Planning and Development
30 S. Nevada Ave., Suite 701
Colorado Springs, CO 80903

Final Report - Corrections Required **Application No. PDZD-26-0017**

Description : PDZ Development Plan for the Paint Mines at Reagan Ranch comprised of 102 single-family attached residential lots on 15.283 acres.

PDZ DEVELOPMENT PLAN

TYPICAL SECTION
HIGH DENSITY SINGLE-FAMILY RESIDENTIAL ROAD
(30' PUBLIC ROW)
NOT TO SCALE

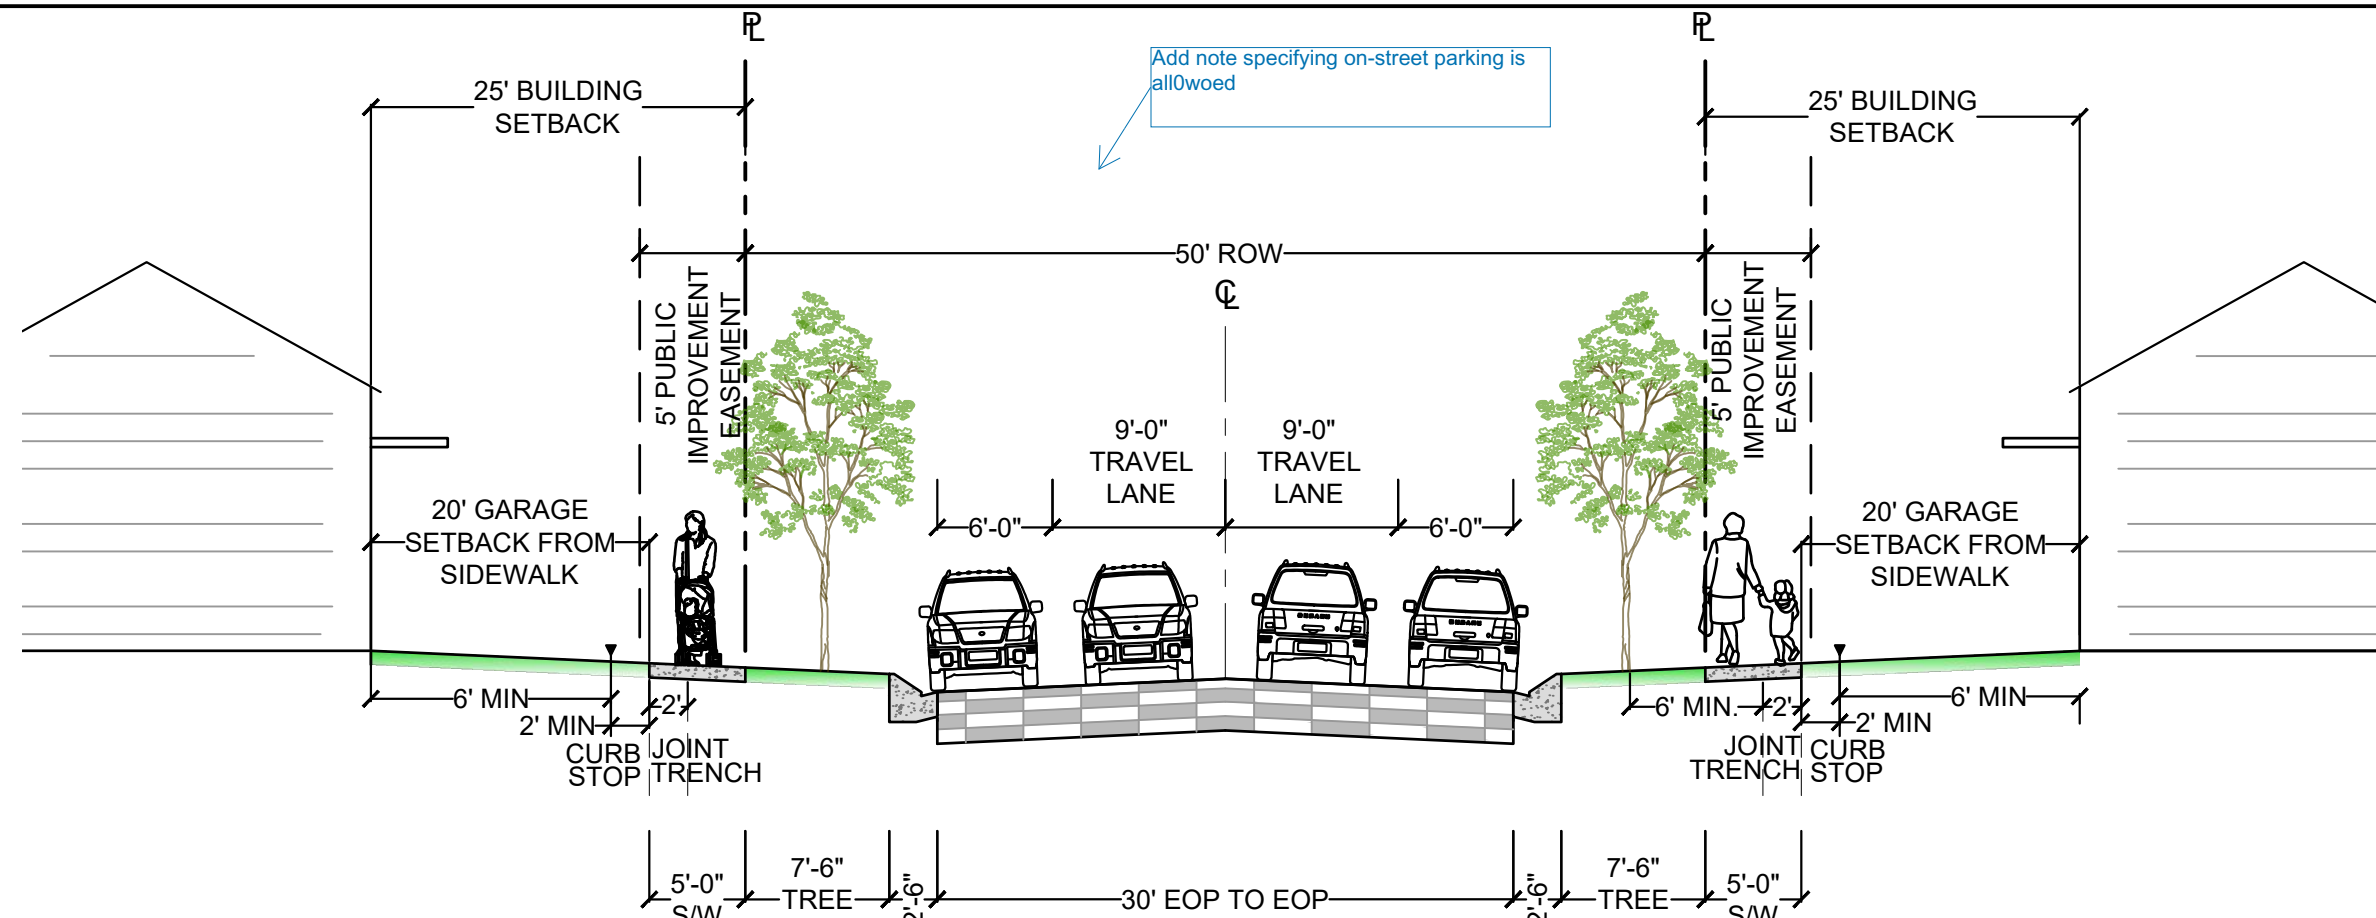
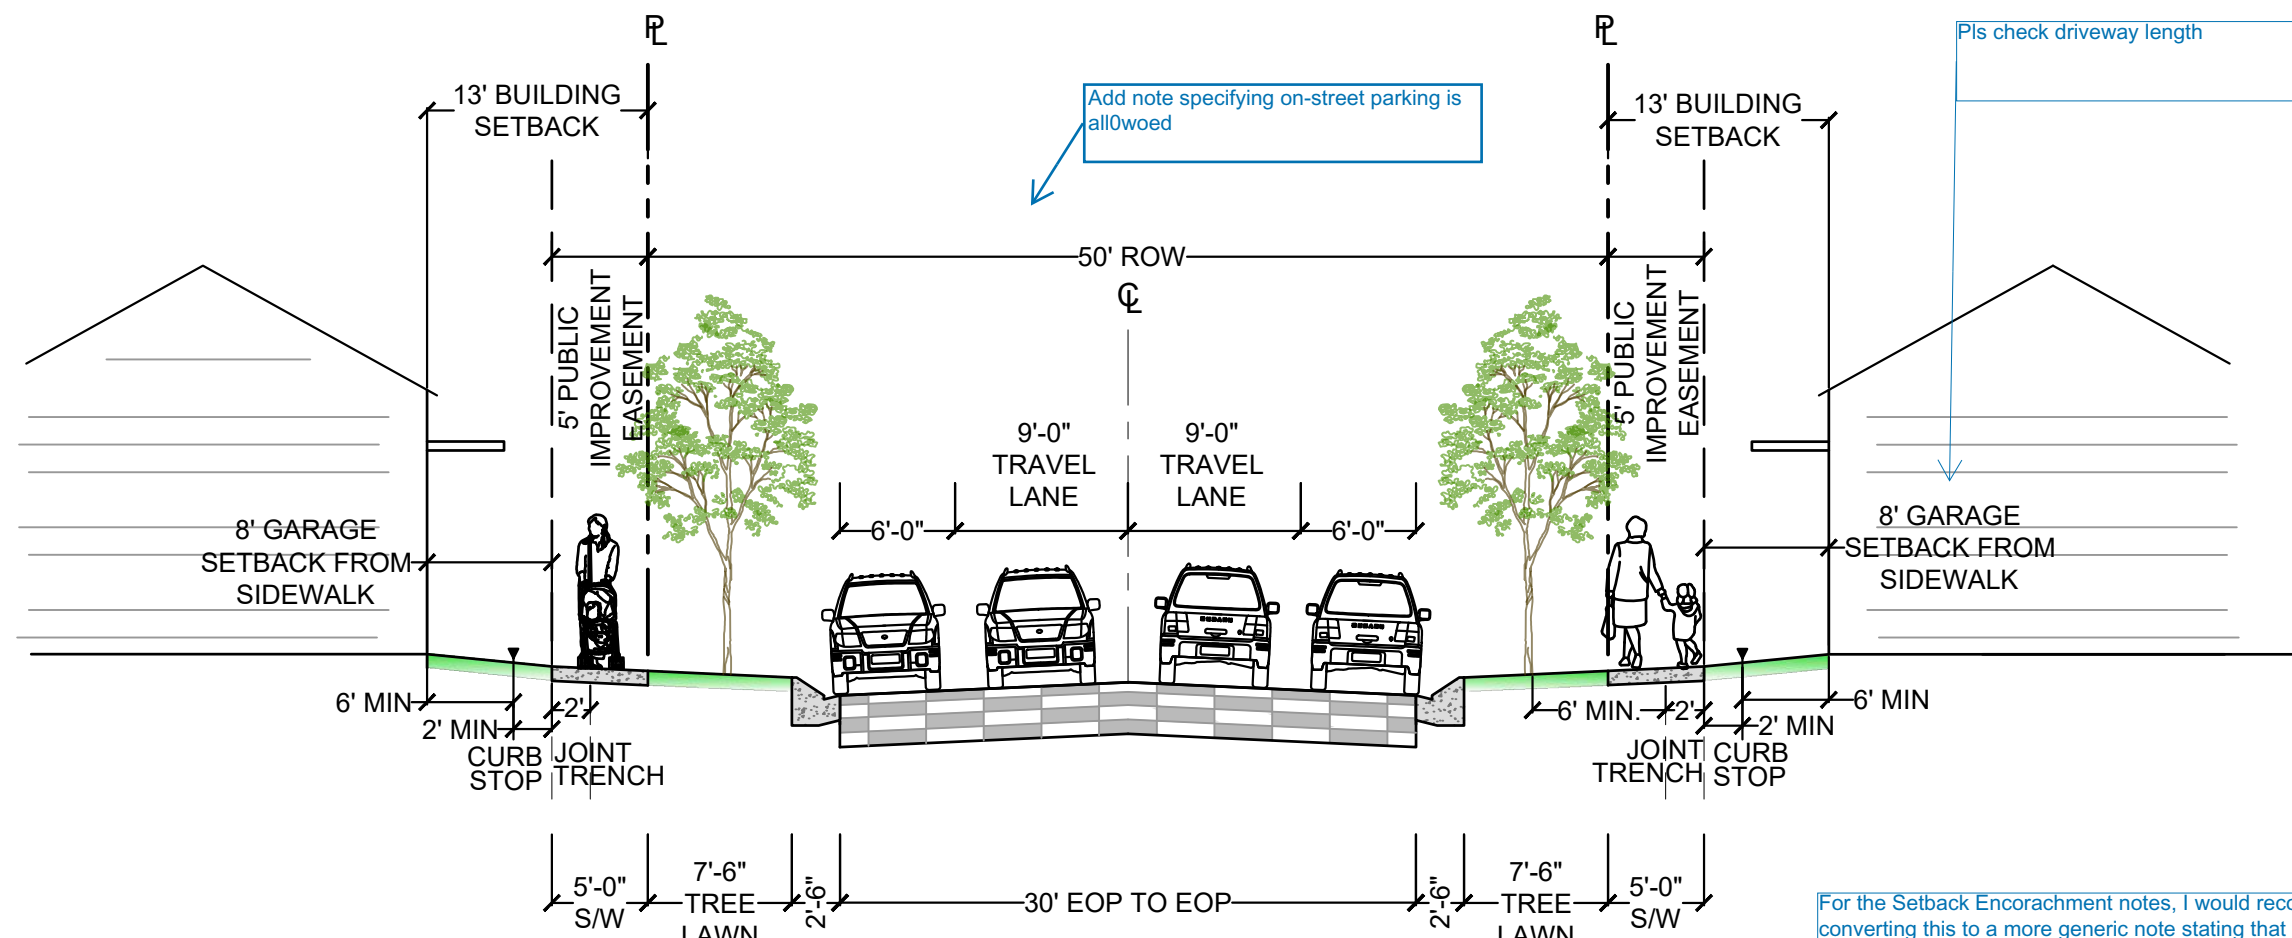
Show or reference A3-10 from the WLESS

Add note: "Gas meters must be a minimum of 3-feet from doors, operable windows, or any vents or openings in walls."

Add note "CSU Field Engineer to determine final gas/electric meter, transformer, and service line locations. Contact Field Engineering at 719-668-4985 (Gas) or 719-668-5564 (Electric) with any questions."

Info Only: Per GLESS 4.05.d.3.a. for new residential construction, Gas meter shall be placed 5' from front corner of building.

Gas and electric meter locations need to be shown and labeled on lot typical diagrams. Please also show the curb stop and indicate the horizontal separation from building and sidewalk (trench).

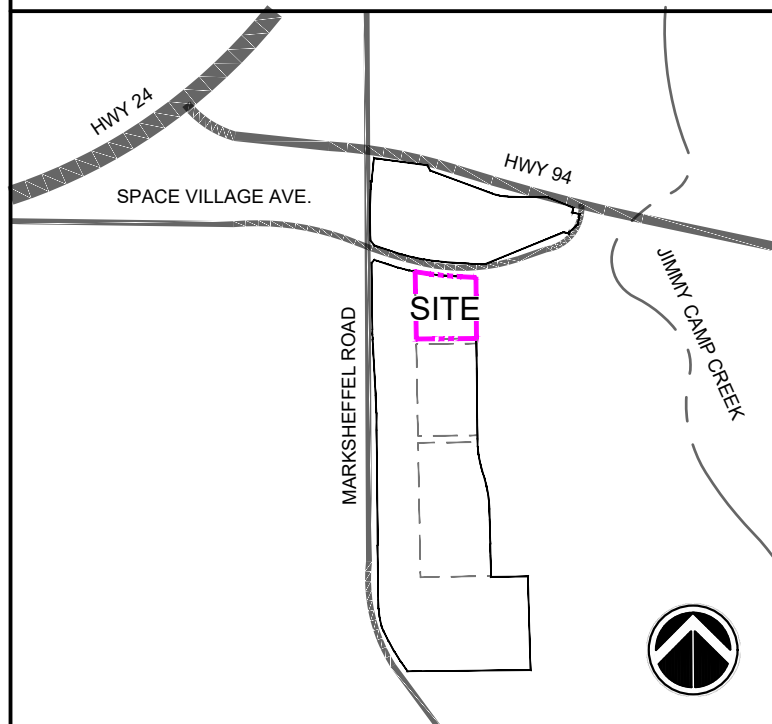
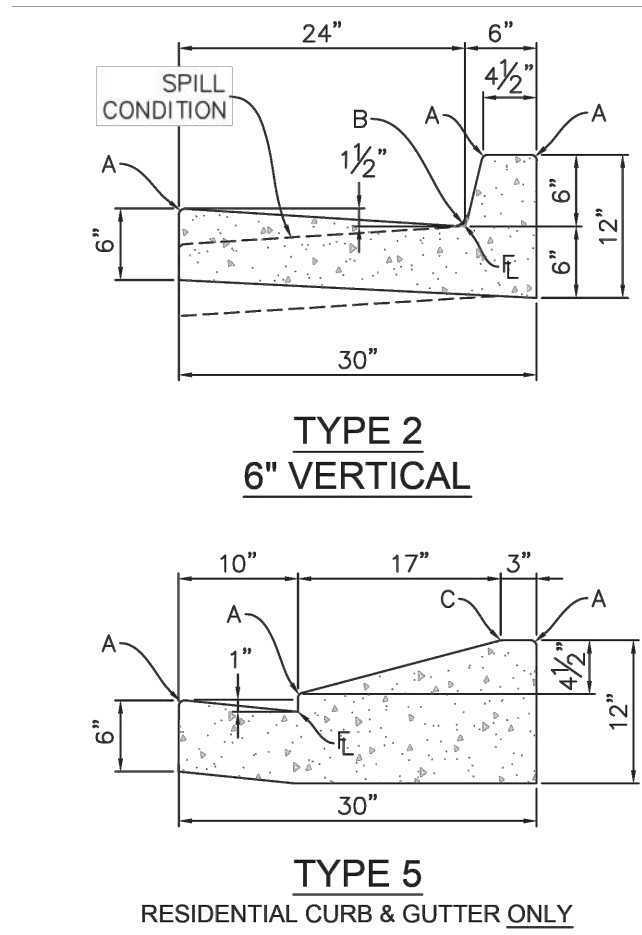
For the Setback Encroachment notes, I would recommend converting this to a more generic note stating that setback encroachments shall be permitted as defined in Section 7.4.203.

7.4.203: EXCEPTIONS AND ENCROACHMENTS - limits this encroachment to 30".

**PRELIMINARY
GRADING PLAN**

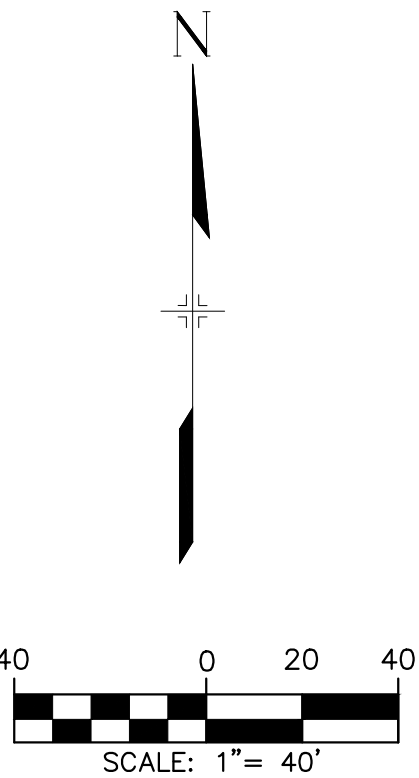
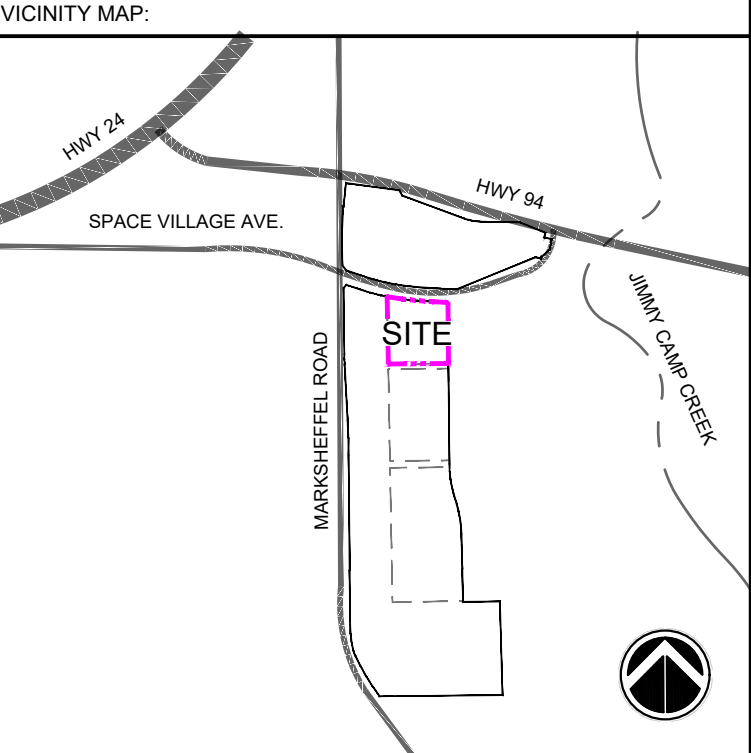
Info Only: RPA within public ROW is not allowed without City Engineering approval.
City Engineering will review and comment upon this during its Development Plan review.

**PRELIMINARY
UTILITY & PUBLIC
FACILITIES PLAN**

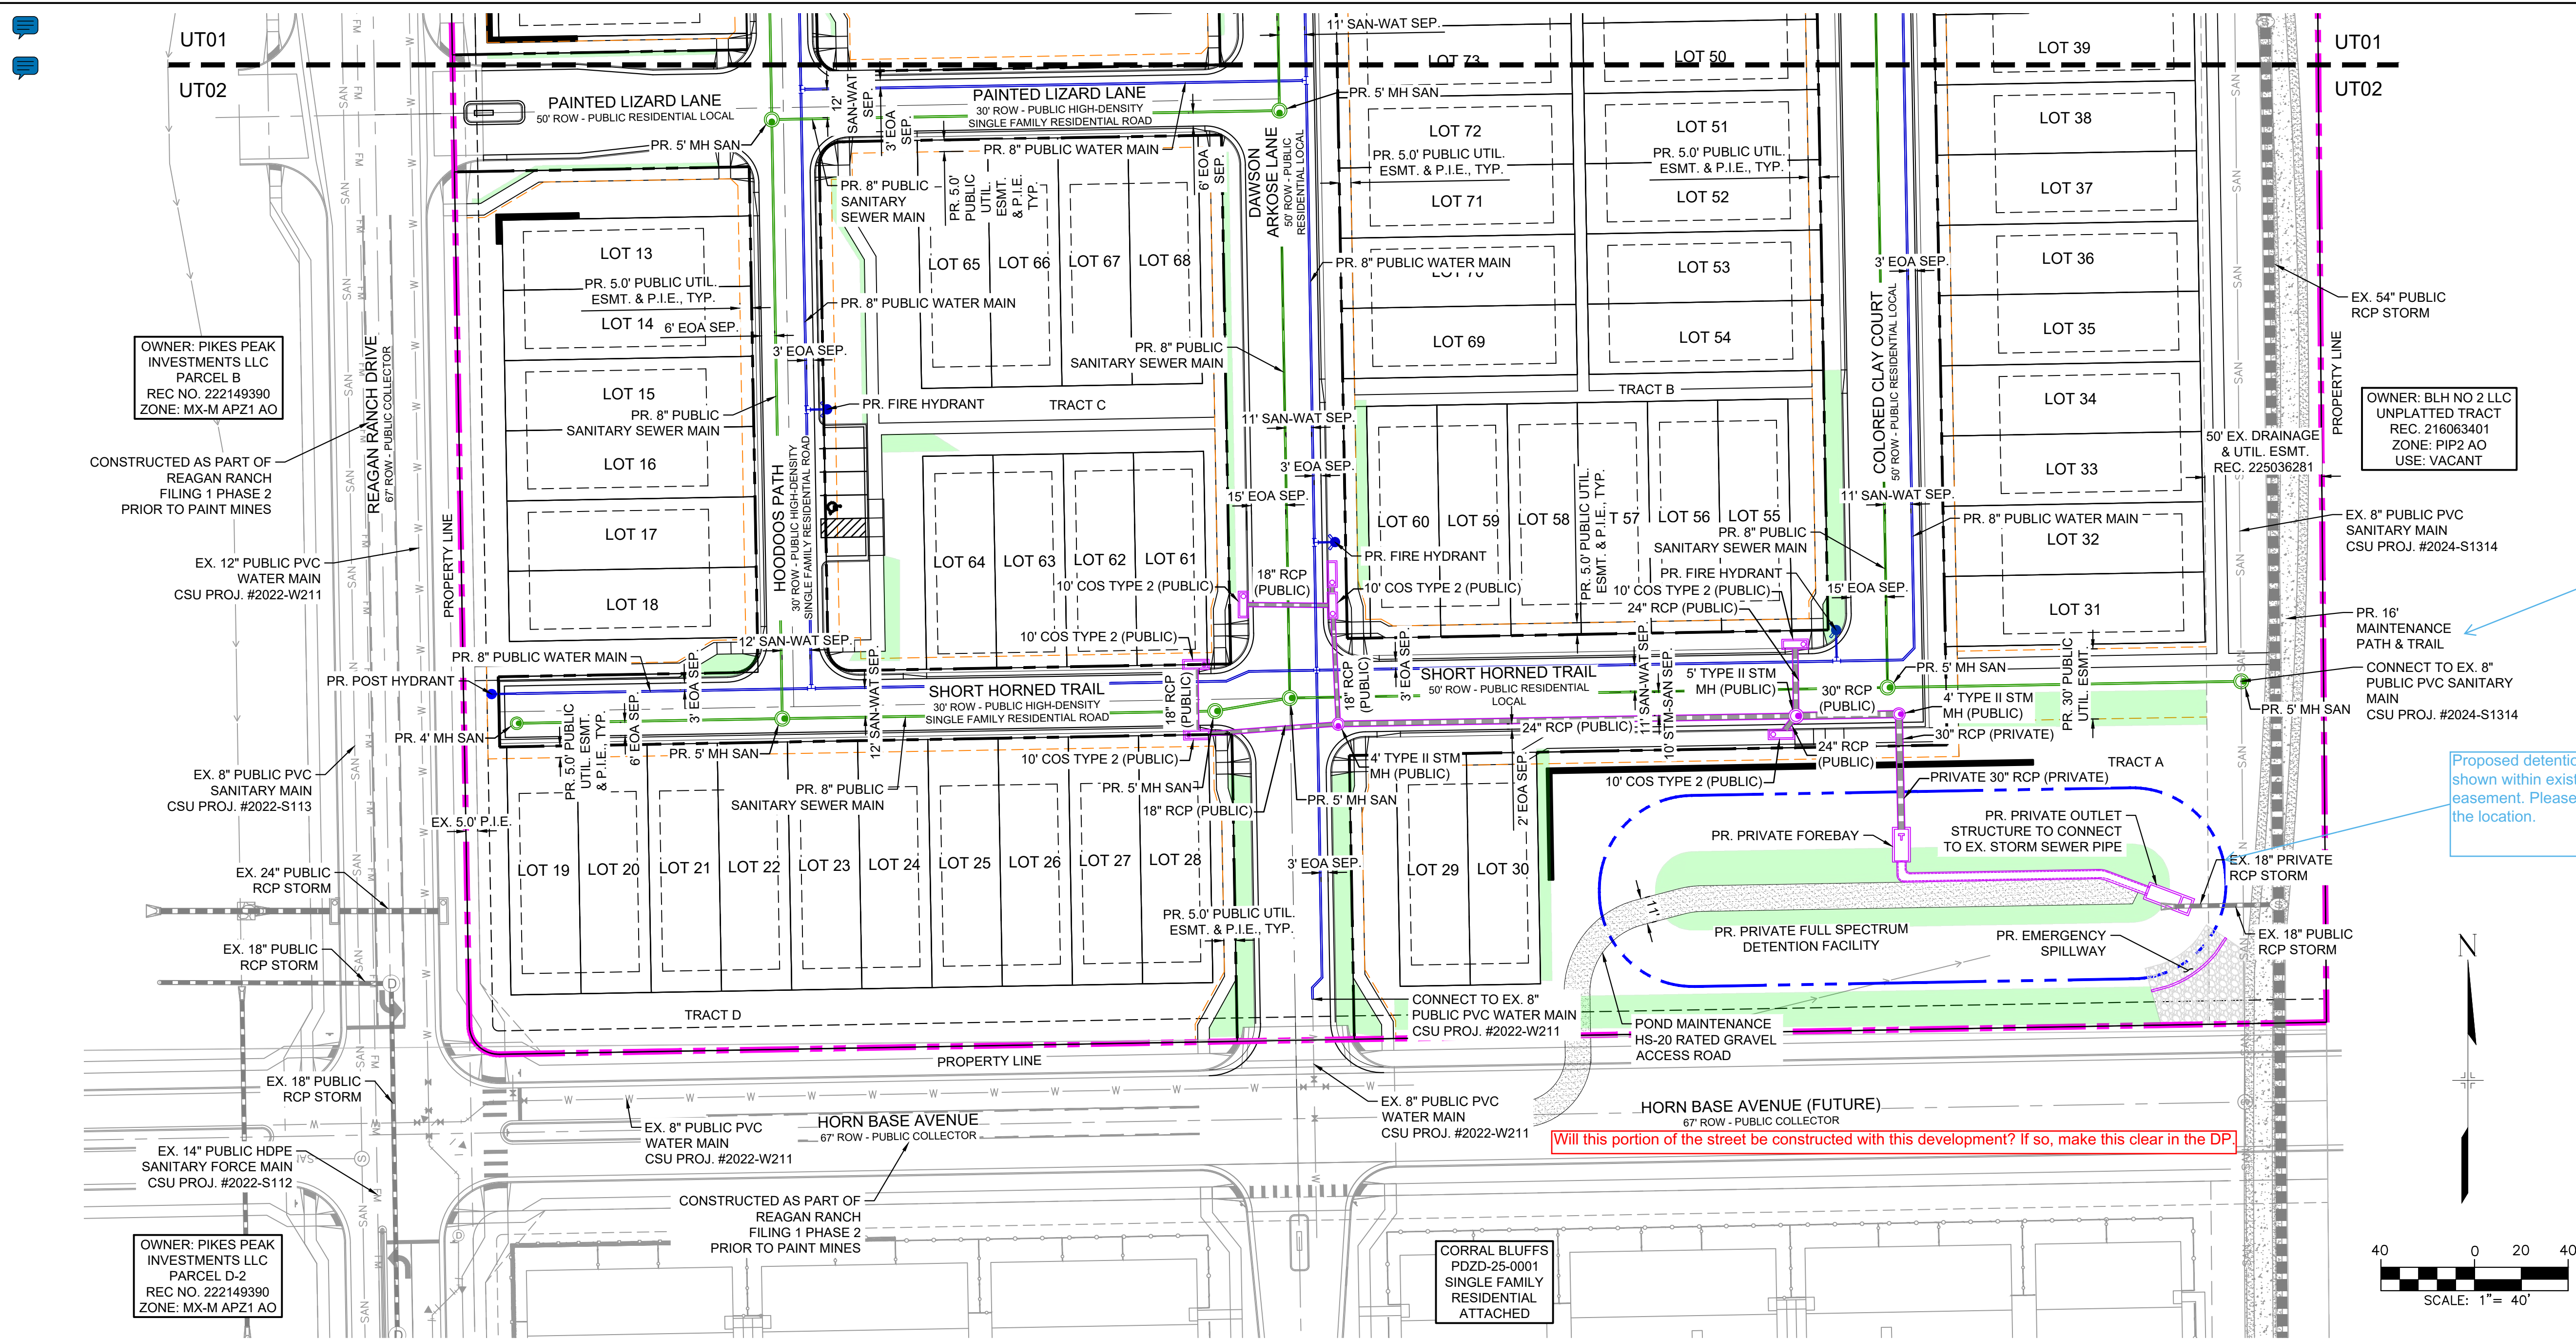
Proposed detention pond is
shown within existing
easement. Please revise
the location.
